Virgil C. Summer Nuclear Station (VCSNS) Units 2 and 3
Combined License Nos. NPF-93 and NPF-94
Docket Nos. 52-027 & 52-028

Subject: VCSNS Units 2 & 3 LAR 13-24 R1 S1: Supplement 1 to Revision 1 of
Request for License Amendment: Containment Internal Floor Module
Connections

Responses to NRC Staff Comments
(Publicly Available Information)
(LAR 13-24 R1 S1)

Figure 2: Elevation View of CA37 Floor to CA01 Wall Connection

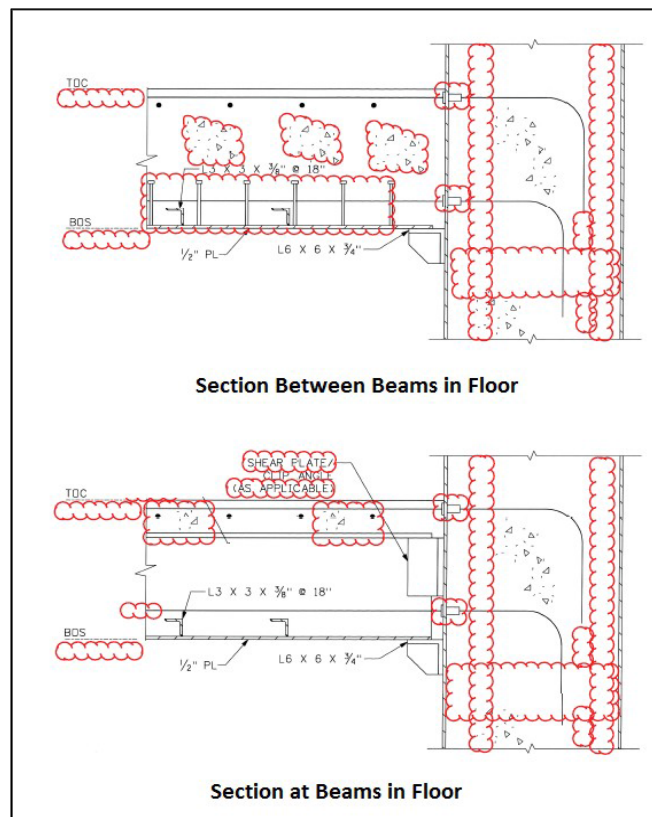
Provide a table to demonstrate the demand to capacity ratio of the connection at various sample locations, including locations where the top of the wall is at the same elevation as the top of the floor.

Example of evaluation for the CA37 module floor-to-CA01 wall connection (Detail 1)

Figure 2 (revised UFSAR Figure 3.8.3-17 (Sheet 1 of 2) as proposed in [SCE&G LAR 13-24 R1](#) and shown below) shows the configuration of the CA37 module floor-to-CA01 wall connection (Area 4 in Containment, top of floor elevation 107'-2"). This connection is composed primarily of encased steel beams that are welded to continuous stiffened angle beam seats. The seats are continuously welded to the CA01 module wall faceplate. Additionally, there are top and bottom dowels that connect the CA37 floor to the CA01 wall. At some locations where the encased beams are heavier to carry heavier loads, such as the Core Makeup Tank, there are heavy beam seats instead of the continuous stiffened angle. These heavy beam seats are referred to as beam pedestals.

Table 1 describes the interaction ratios for the CA37 module floor to CA01 module wall connection (Area 4 in Containment, top of floor elevation 107'-2").

**Table 1: CA37 Module Floor to CA01 Module Wall Connection
Design Interaction Ratios (IR)**

Item	Structural Item	Demand	Capacity	IR	Governing failure mode
1	Top dowel	1.32 in ² /ft	2.00 in ² /ft	0.66	Maximum 0.3% concrete compressive strain in bending per ACI 349 requirements.
2	Bottom dowel	1.96 in ² /ft	2.00 in ² /ft	0.98	Maximum 0.3% concrete compressive strain in bending per ACI 349 requirements, determined conservatively neglecting the contribution of the encased beams, the floor bottom plate and the weld to the floor seat.
3	Continuous Stiffened Beam Seat	4.94 kip/in	5.57 kip/in	0.89	Weld connecting floor bottom plate to continuous angle seat, determined conservatively neglecting the contribution of the bottom dowels.
4	Beam Pedestals	12.6 kip/in	50.4 kip/in	0.25	Weld connecting beam to beam pedestal.

Table 1 displays the reinforcement required (see items 1 & 2 in the table) in square inches per linear foot to withstand the demand forces due to axial, bending, & twisting loads from the ANSYS finite element analysis model while neglecting the contribution of the beam seats. The capacity is presented as the available square inches of steel per linear foot.

Table 1 also displays the continuous stiffened angle floor seat (see item 3 in the table) "demand" due to tension (axial, bending, & twisting moment), in-plane shear, and out-of-plane shear loads from the ANSYS finite element analysis model, along with locked-in stress imparted to the seats during concrete placement. The forces applied at the stiffened seat for the evaluation are conservatively based on the largest demand obtained from the analysis model at the CA37 floor to wall connection, while neglecting the contribution of the bottom dowels. The continuous stiffened beam seats are demonstrated to meet the design requirements.

Finally, Table 1 also displays the beam pedestal (see item 4 in the table) "demand" due to in-plane shear and out-of-plane shear loads from the ANSYS finite element analysis model. The beam pedestals are analyzed in a similar fashion as the continuous stiffened angle beam seats with the exception that they see larger loads due to the Core Makeup Tank being supported on this area of the floor.
